Re: Chick-fil-A
NWC of Coors & St. Joseph Dr. NW 87120
Traffic Circulation Layout
Engineer's/Architect's Stamp 1-28-19 (G11D069C)

SHEET TITLE
SITE PLAN & TRAFFIC CIRCULATION LAYOUT
DWG EDITION ---

Sheet
C2.0

**Re: Chick-fil-A, NWC of Coors & St. Joseph Dr. NW 87120
Traffic Circulation Layout, Engineer's/Architect's Stamp 12-06-18 (G11D069C)**

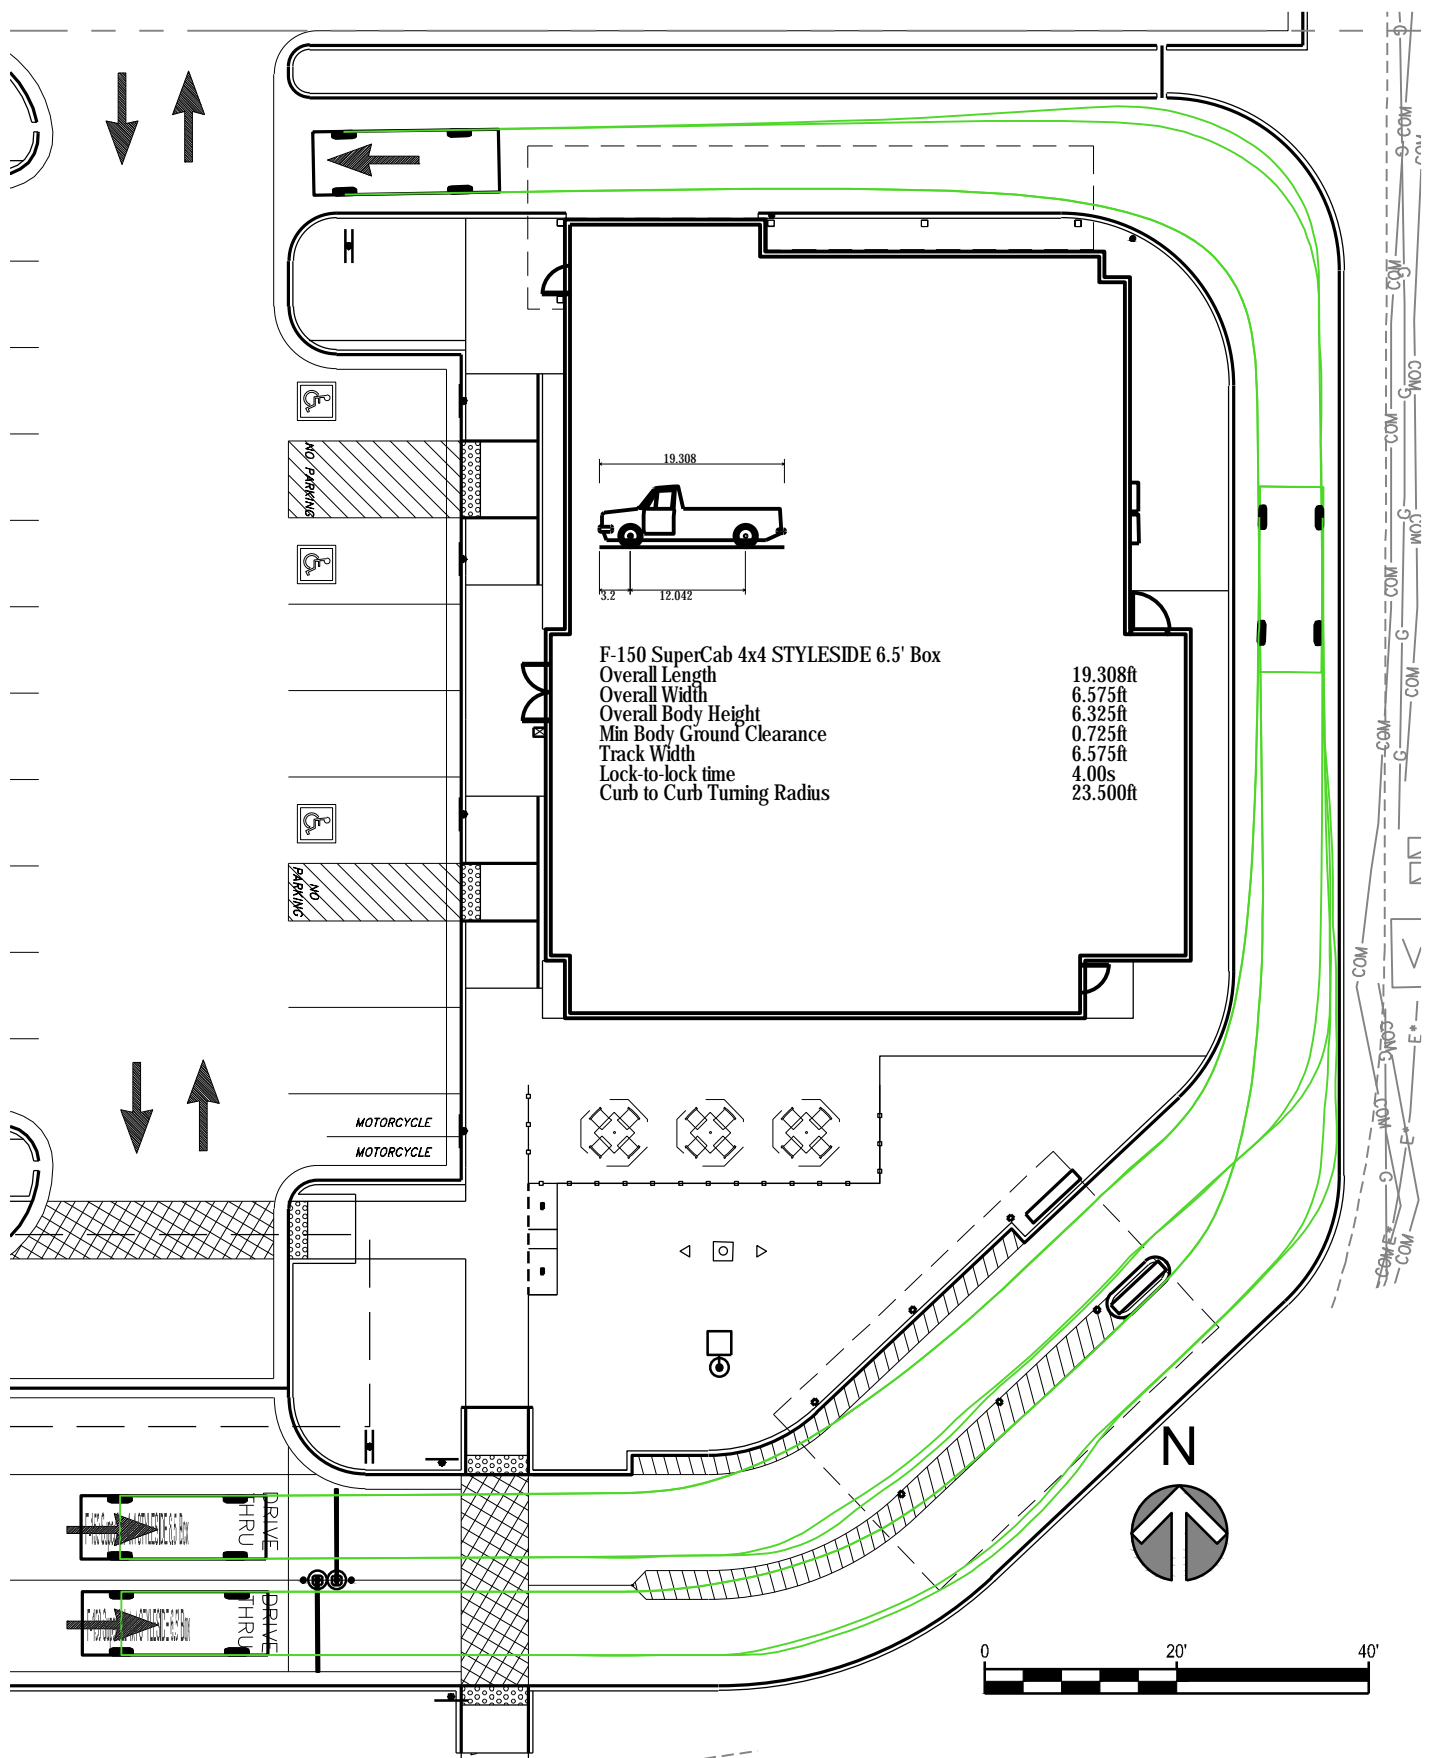
-
1. **E. Drive-Through Facilities.** Minimum lane widths are 12 foot minimum with a 25 foot minimum radius (inside edge) for all turns. (A 15 foot radius can be used with an increase in lane width to 14 feet).

Response: Due to the following site constraints we are not able to meet this requirement.

- There is no storm sewer on the site, requiring the site to surface flow to the pan in the middle of the shared driveway. This eliminates the ability to lower the elevation of the drive through lane.
- Widening the drive through to the east results in slopes that exceed 4:1, the maximum per city code.
- Widening the drive through to the west results in the loss of 11 parking spaces.
- Widening the drive through to the east and adding retaining walls results in a conflict between the retaining wall and existing underground utilities.
- Using a 25' inside turning radius impacts structural elements of the building, we have used an 18' inside and outside radius to allow for a larger turning area.

We were able to widen the drive through lane to 11' behind the building by eliminating the landscaping in front of the building. We were able to widen the drive through to 12' to the North of the building per code. Based on the attached turning analysis, we feel the prepared layout meets the intent of the code and will accommodate most vehicles. Please note that the turning software limits us to an older version of the F-150, the 2019 version is ¼" longer and 1" wider. If there are any further issues with the drive through width we are happy to discuss the challenges we are facing with the site in more detail.
